**HYDROMODIFICATION MANAGEMENT
STUDY FOR
MEADOWOOD VESTING TENTATIVE MAP**

Job Number 15956

**April 1, 2009
Revised: August 18, 2009**

**RESPONSE TO COUNTY'S COMMENTS FOR THE
HYDROMODIFICATION MANAGEMENT STUDY FOR
MEADOWOOD VESTING TENTATIVE MAP**

Meadowood Vesting Tentative Map - Flowpaths For Drainage Basin 7000

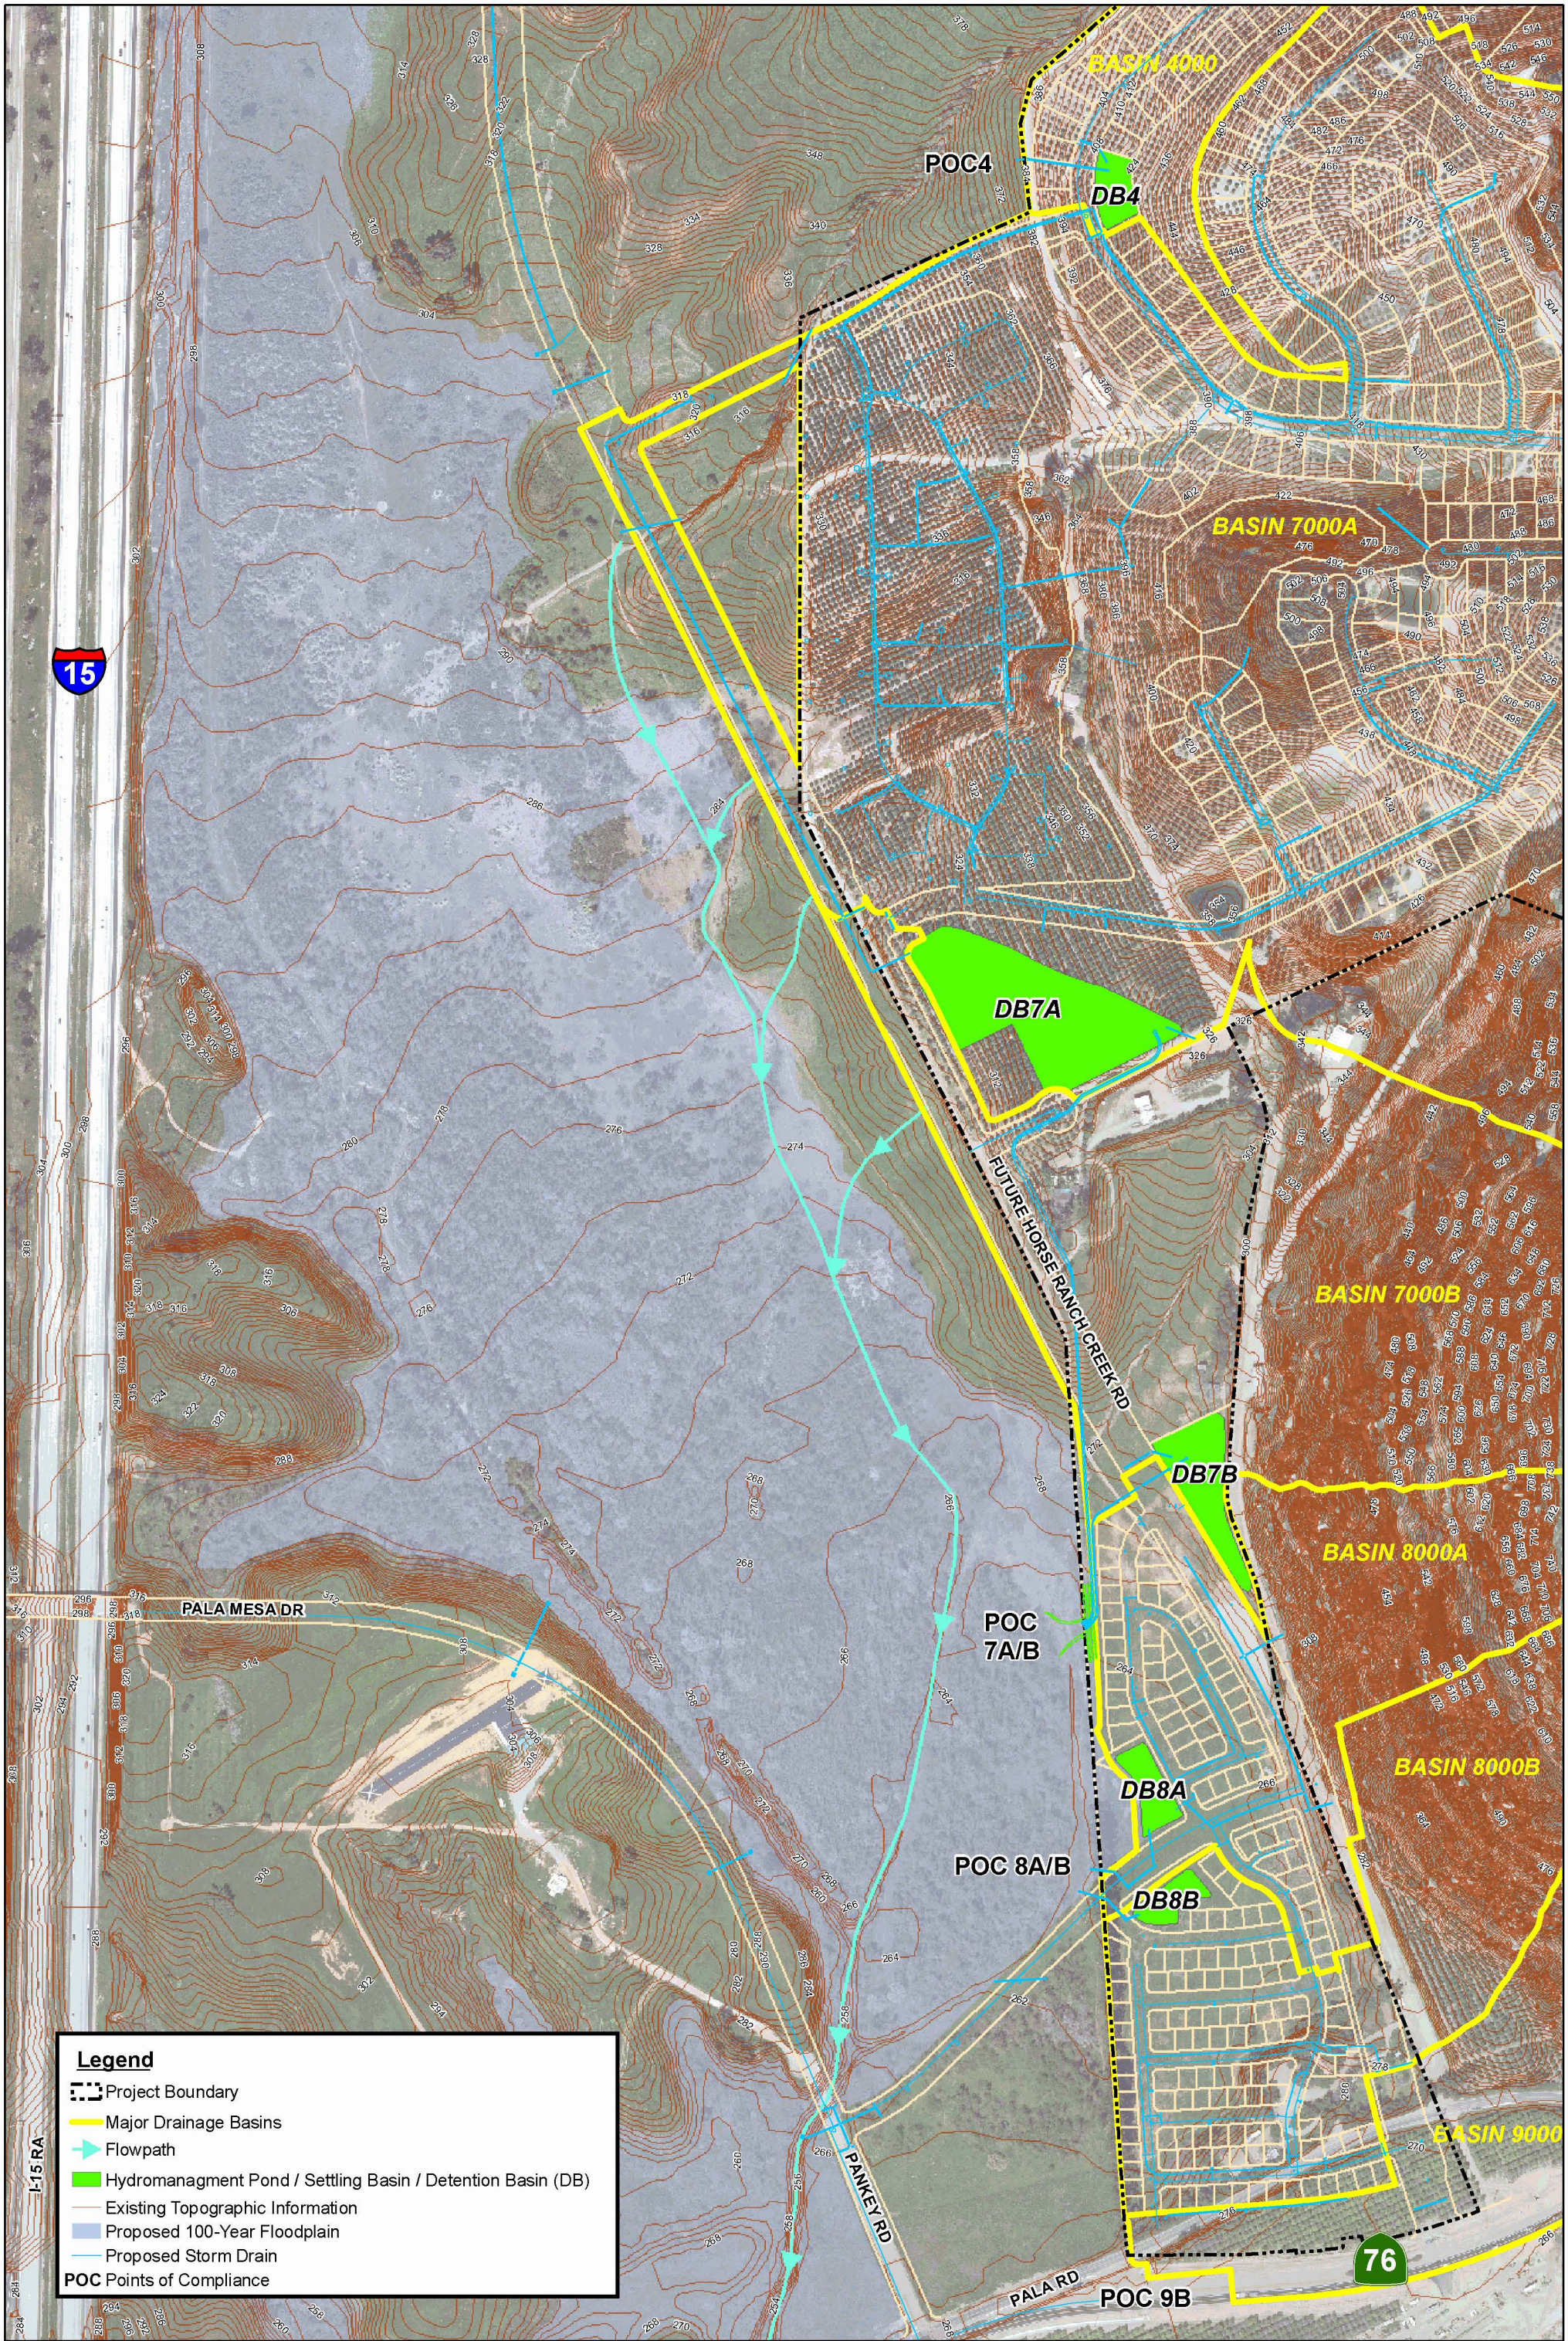
Drainage Basins 700A and 700B. As outlined in the County's comments regarding the Meadowood Drainage Study, the delineation of Drainage Basins 700A and 700B requires reexamination. Drainage Basin 700A is currently modeled with an outlet at Node 712, while flow from Drainage Basin 700B discharges at Node 753 (see Figure 2). However, it appears from the Pre-Project Drainage Map (dated November 14, 2008) that much of the flow from 700A would actually combine with flow from 700B, with the combined flow discharging at Node 753. Therefore, a single POC could potentially be used for these two drainage basins unless significant flow actually reaches Node 712. In the latter case, two POCs would be required: at Node 753 and Node 712.

Rick Engineering Company's Response: As discussed at the meeting at the Regional Board with County of San Diego, Pardee Homes, and Rick Engineering Company representatives the project is assigning the point of compliance for Drainage Basin 7000 (7000A and B combined) at the point in the system that needs to be protected rather than the project boundary. As a result the POC has been identified on the updated exhibit located in the revised report. Further discussion of this has been included in the updated text.
